MAY 18, 2026 REGULAR MEETING

Malibu Planning Commission
Regular Meeting Agenda

A. Coastal Development Permit No. 23-073, Variance No. 25-019, Site Plan Review No. 23-035, and Minor Modification No. 24-005 – An application for the construction of a single-family residence and associated development (Continued from March 16, 2026)

Location: 32832 Pacific Coast Highway, within the appealable coastal zone
APN: 4473-017-023
Owner: Sun is Shining, LLC
Case Planner: Senior Planner Achis, AICP, 456-2489, ext. 247

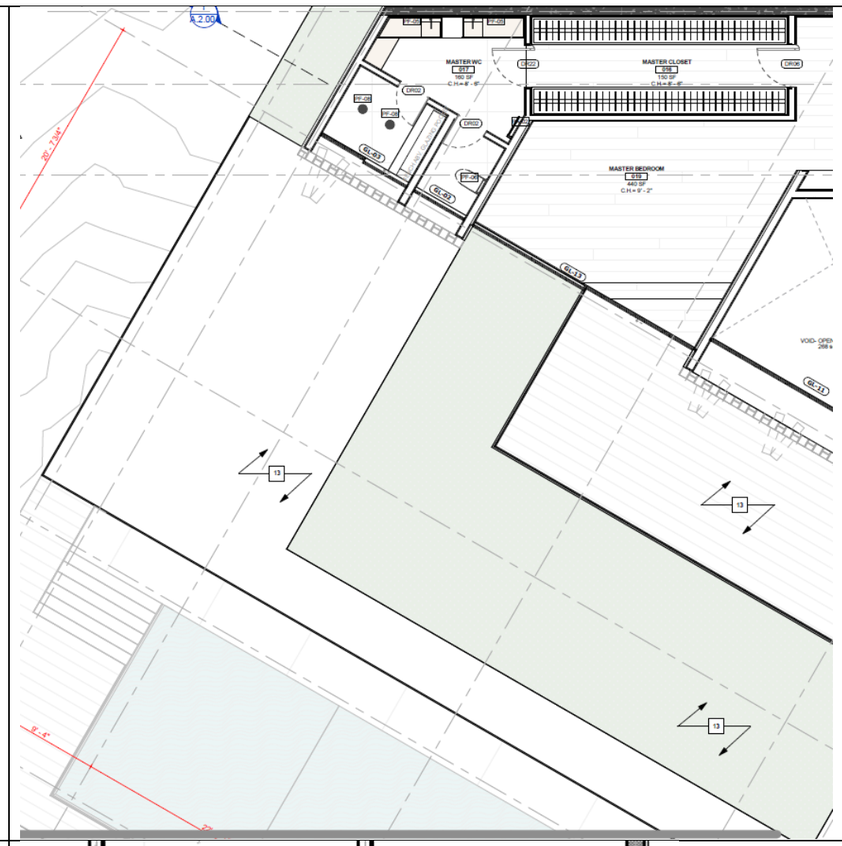
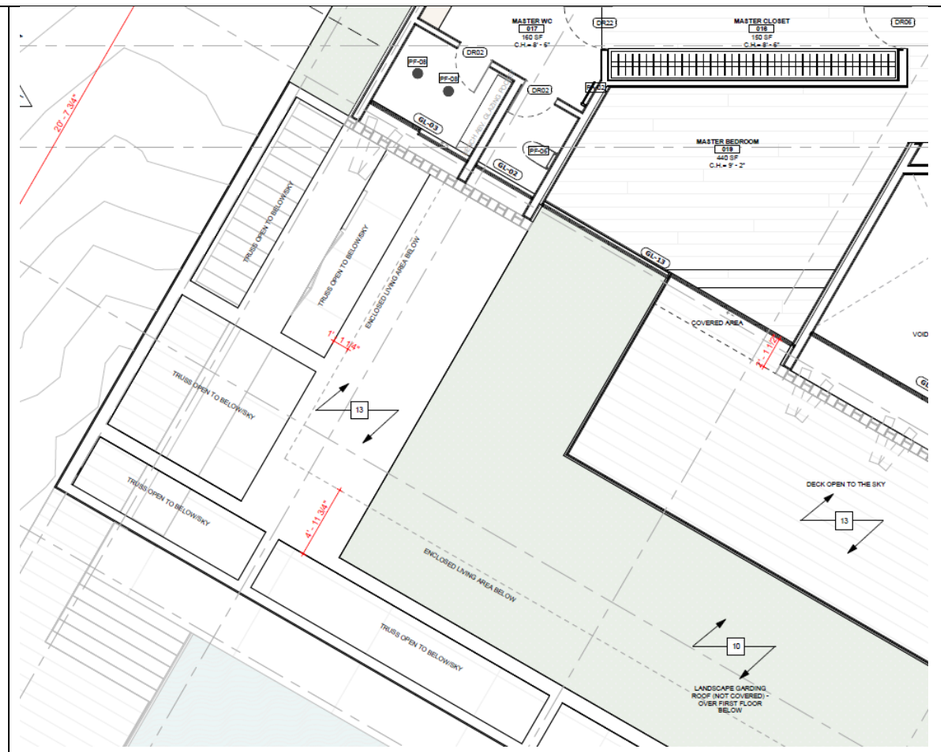
A.1.100			Dimensioned covered area over sink, which is required by EH, and over prep area at 2'-6". Area over the walkway is open truss/pergola- see roof plan.

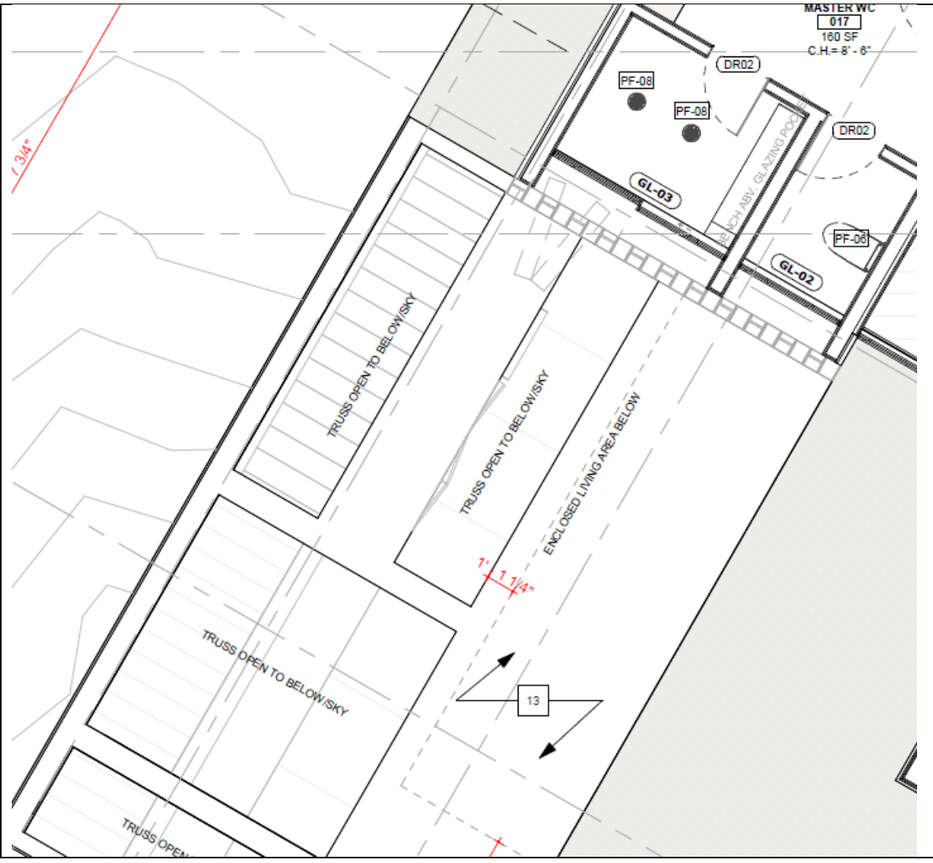
A.1.101			Floor plans have been updated to clarify the proposed open truss/pergola design over exterior areas, the enclosed living area below, and to clearly delineate dimensions of covered areas and areas open to the sky in response to questions regarding conformance with the 6-foot covered area threshold.
A.1.101

A.1.101			
A.1.101			Reduced balcony reflects the reduction of the SFR on the east side. Covered balcony identified as such and dimensioned.

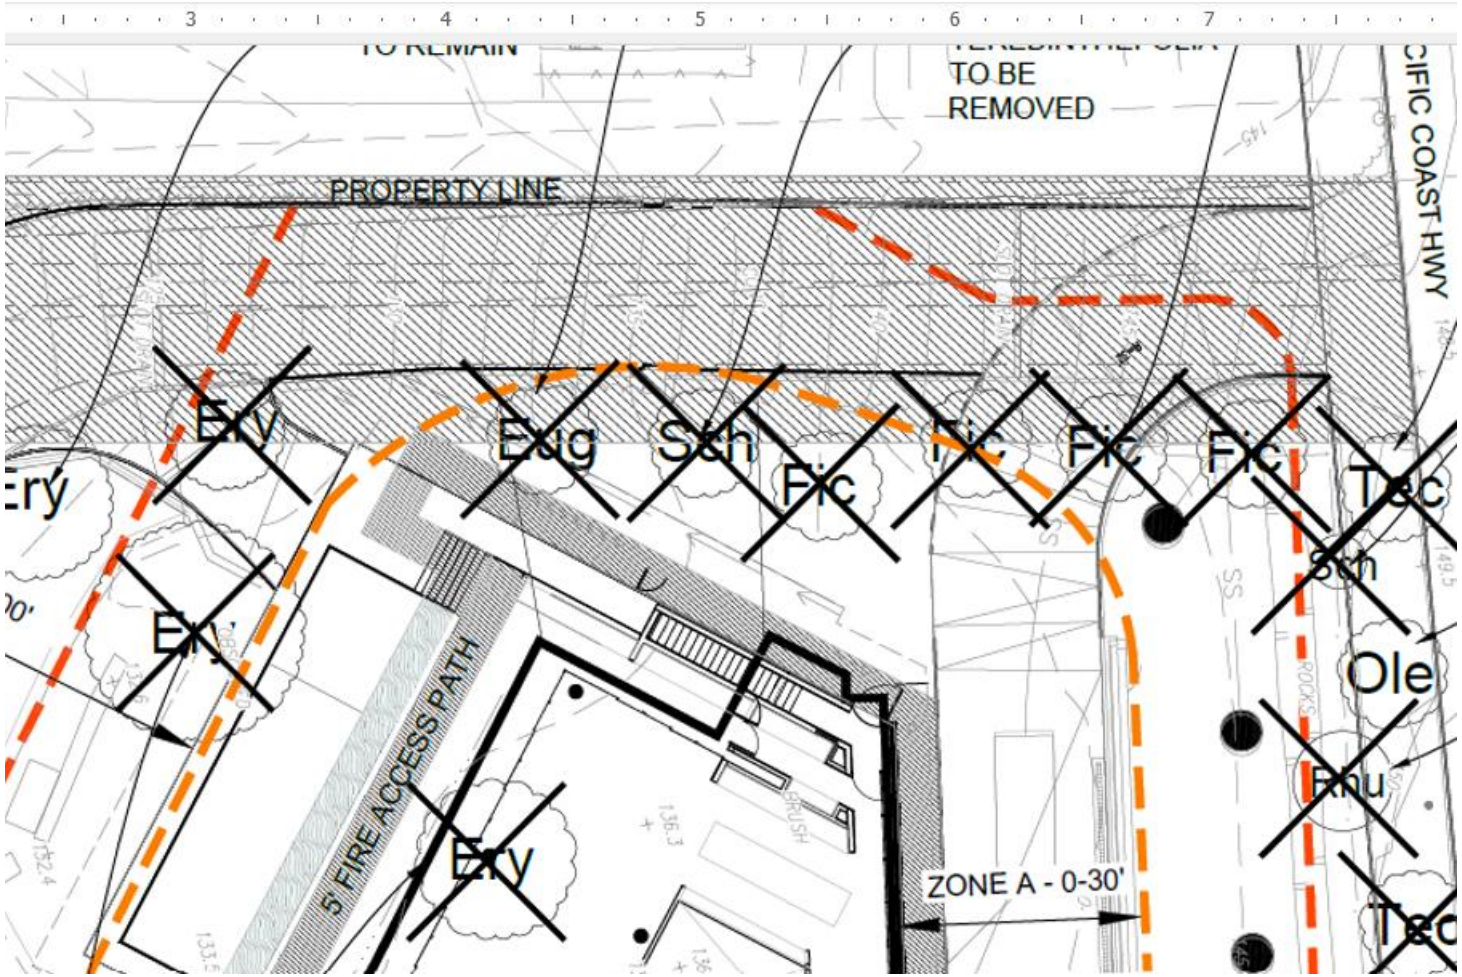
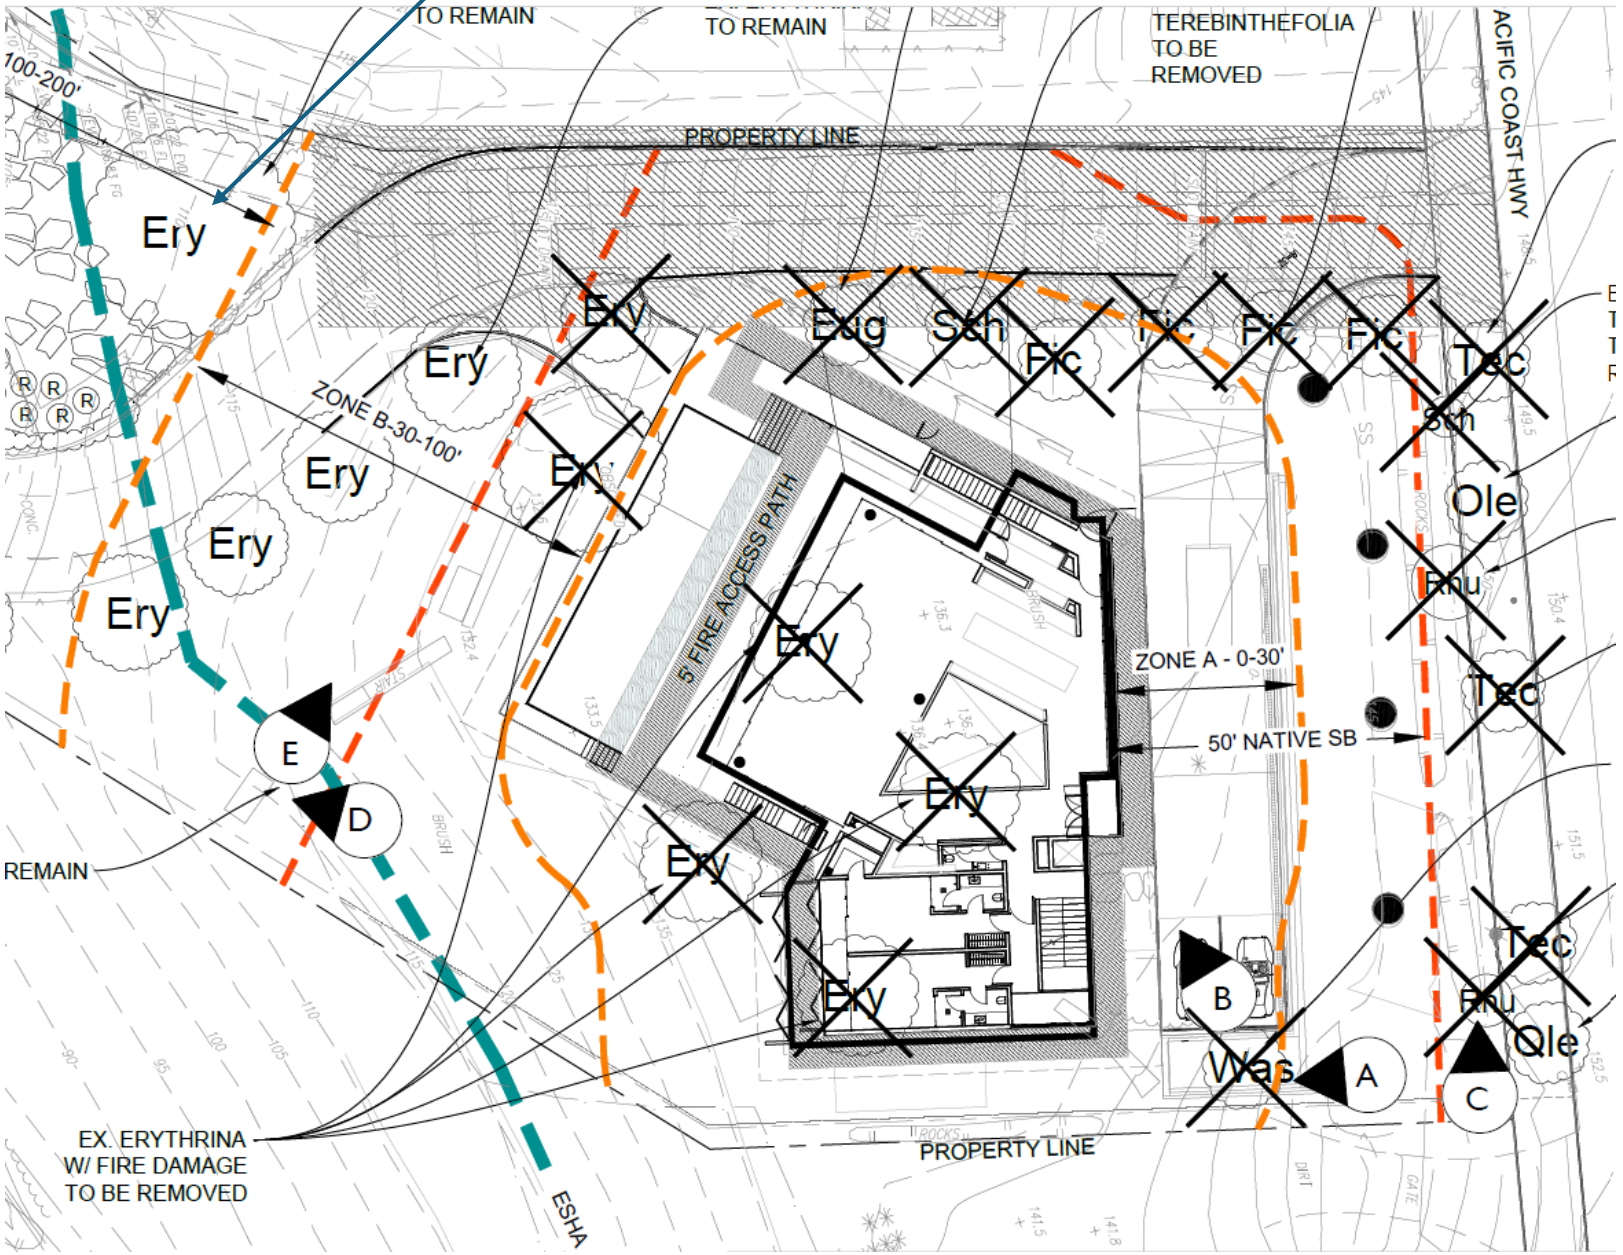
All trees within the proposed view corridor that extend above road grade are proposed to be removed in order to open and preserve ocean views. The site topography drops significantly from PCH, which inherently enhances view opportunities as the parcel descends.

The tree at the bottom of the driveway referenced by the Commission is located on the subject parcel; however, it was installed by the neighboring property owner as part of their entry landscaping. In an effort to maintain good neighbor relations, the owner has sought to retain this tree unless its removal is necessary to achieve compliance.Because the tree is located largely below road grade and is regularly maintained, it does not create a material obstruction to ocean views. To further address this, the owner has proposed a wider view corridor than otherwise required by Code, thereby offsetting the retention of this tree.

Proposed view Corridor

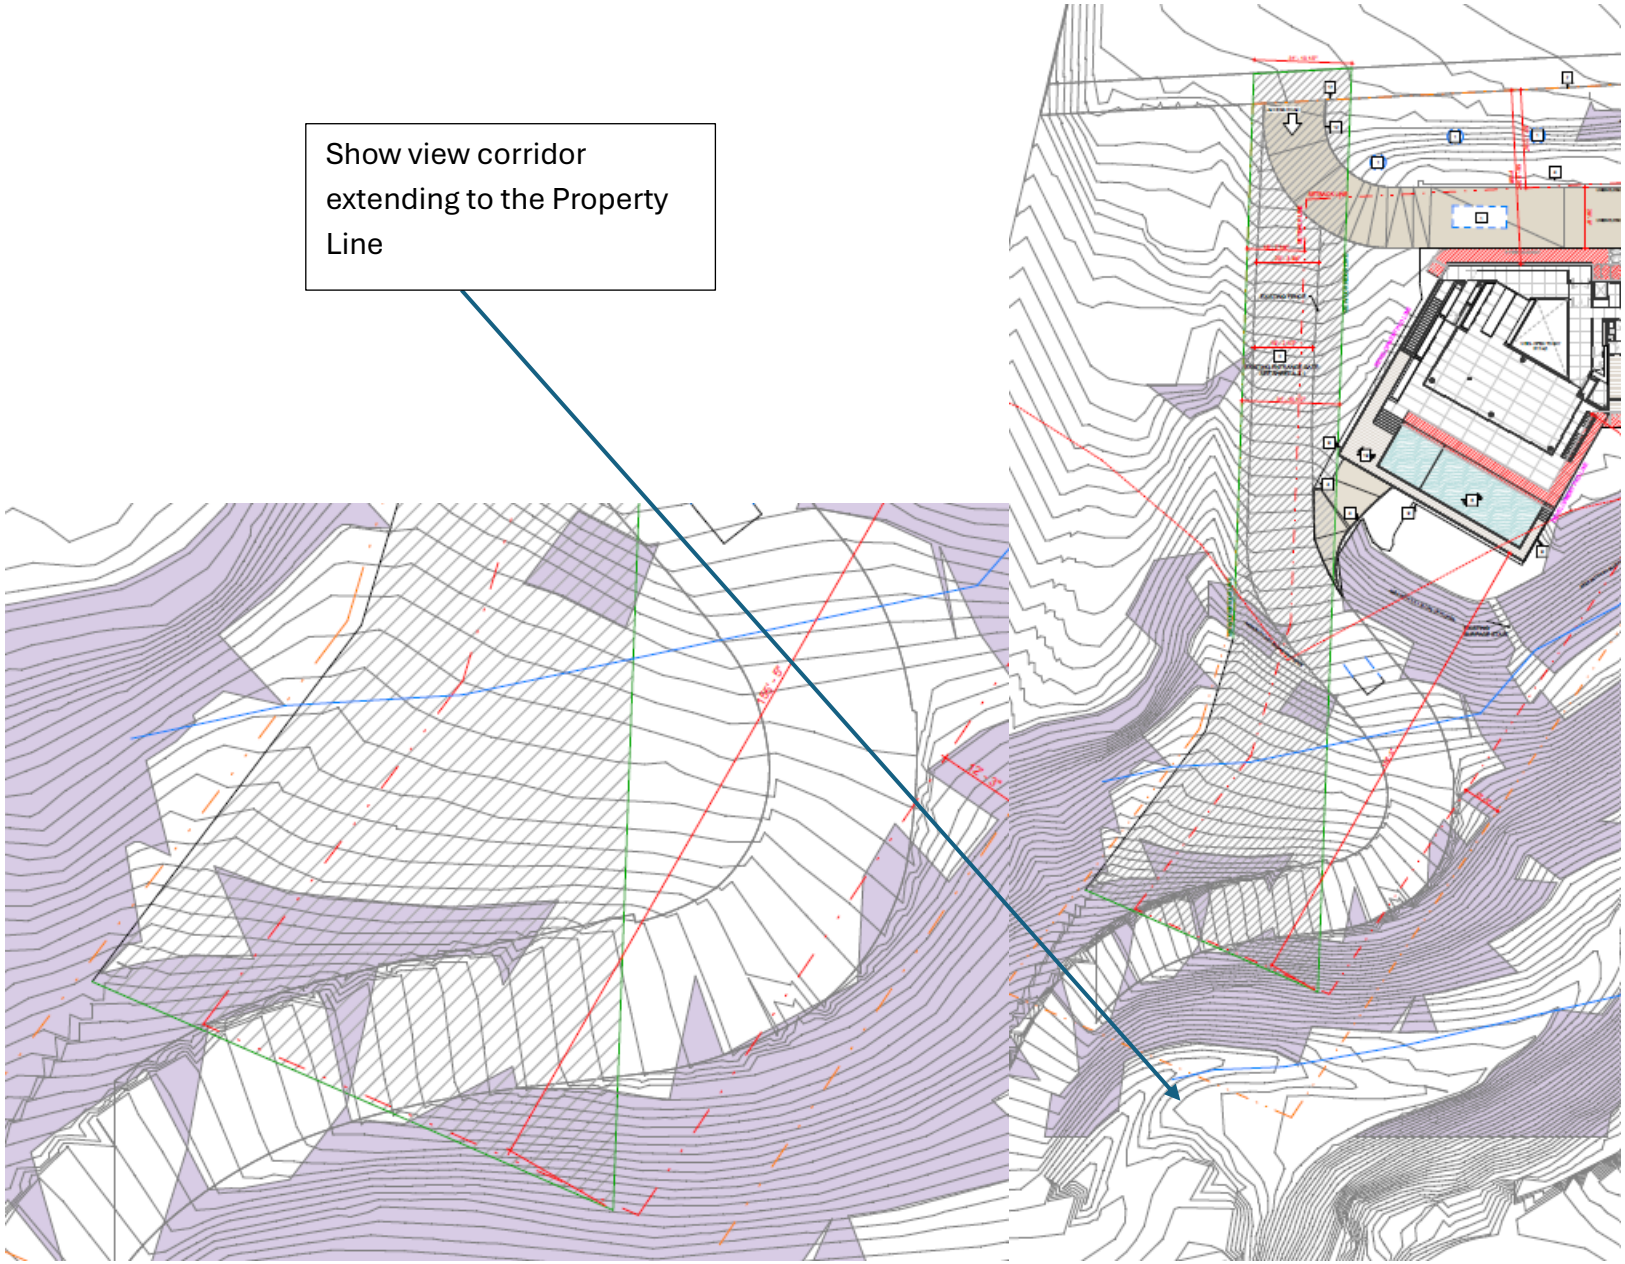
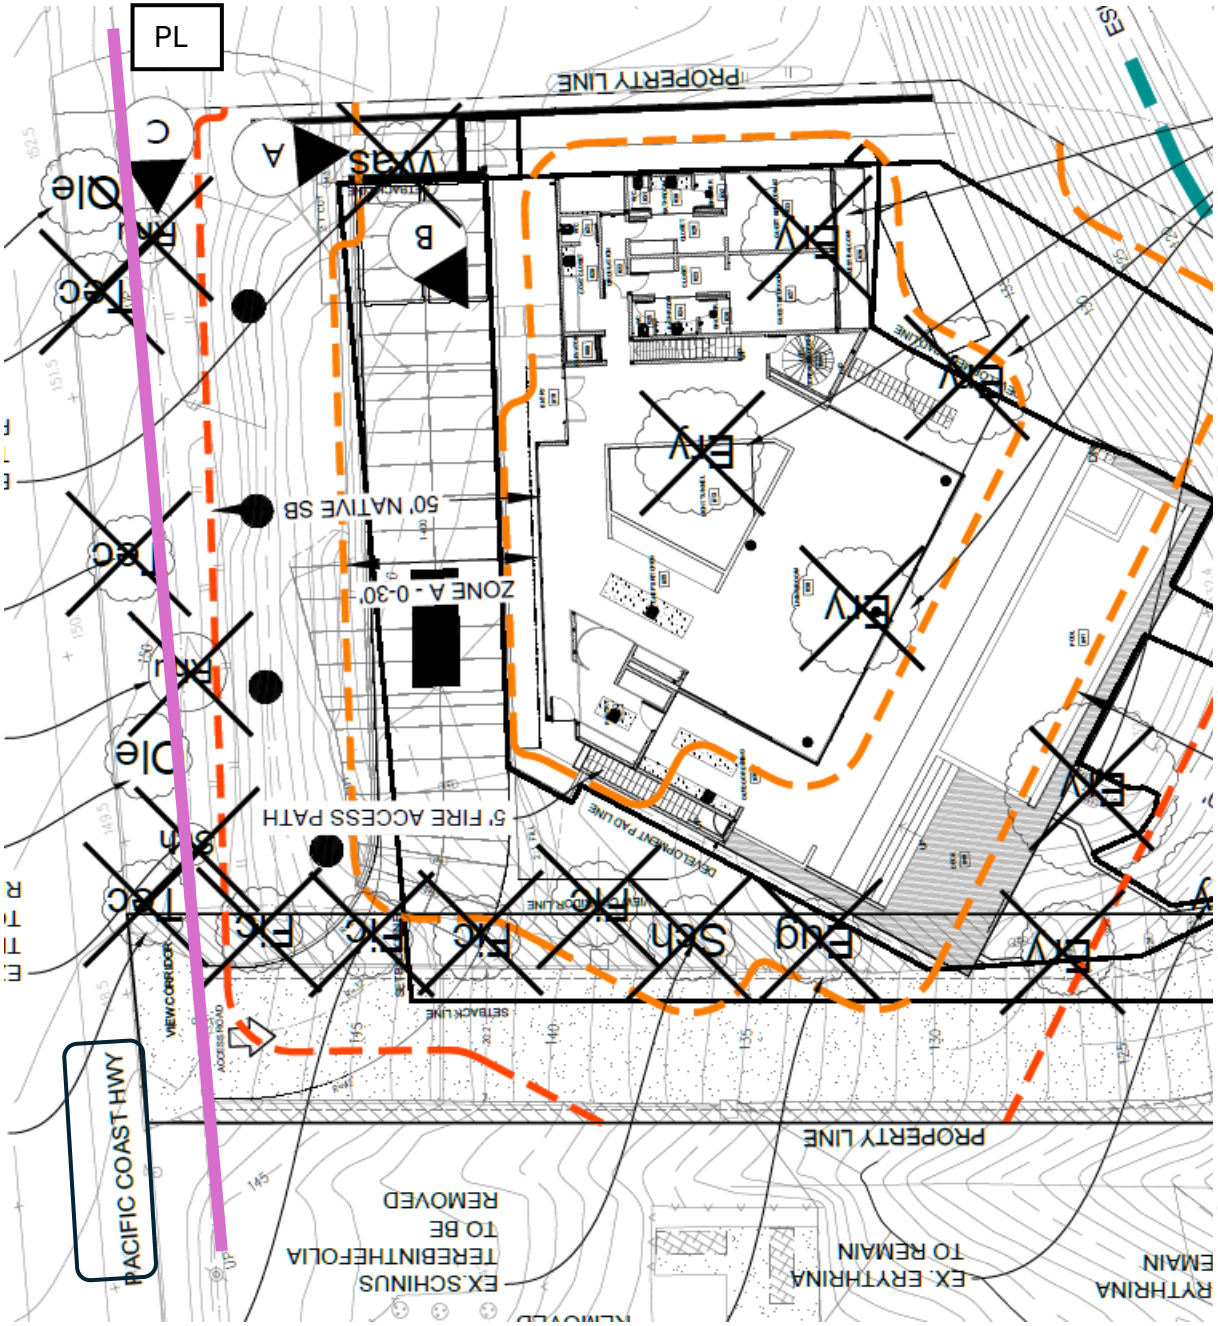
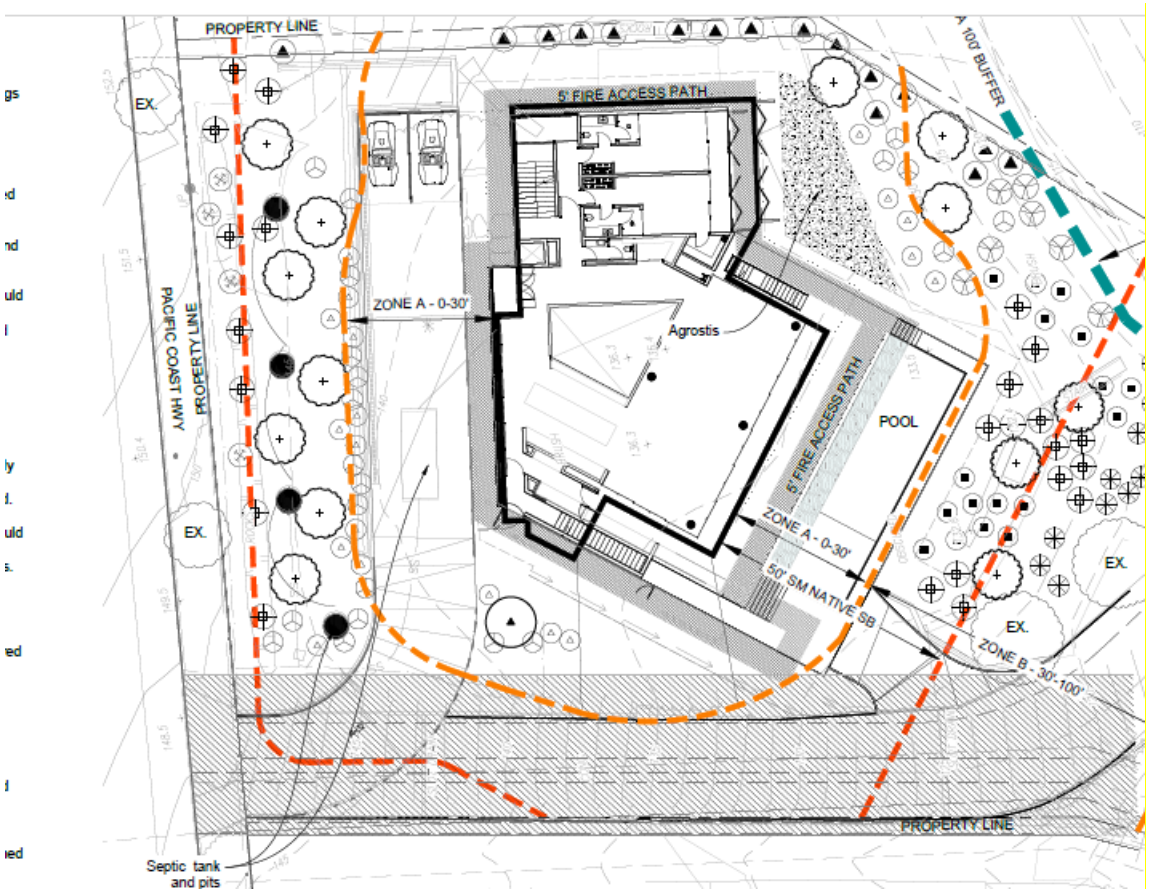
Additionally, the project proposes a more expansive view corridor along the ocean-facing portion of the parcel to meet the intent of the view corridor provisions, even though this approach exceeds the strict language of the Code. While the Code contemplates corridors running parallel to property lines, the proposed design extends the line of sight along the length of the parcel to maximize available views.

It is also important to note that the subject parcel does not front the ocean. There are multiple intervening properties between the site and the coastline, all of which are heavily landscaped and outside the owner's control. The proposed view corridor is therefore located along the western portion of the property—consistent with prior Coastal Commission approval—as this area provides the most meaningful and feasible view opportunities. The opposite side of the parcel is constrained by both the site geometry and intervening development, limiting its effectiveness as a view corridor.

The vegetation on the left side of the purple line (PL) is off-site and within the Caltrans ROW and subject to Caltrans authorization. The owner is proposing to remove the Tecomaria shrubs, which is a fast growing screening shrub. Two fruitless olive trees on either side of the property are proposed to remain.
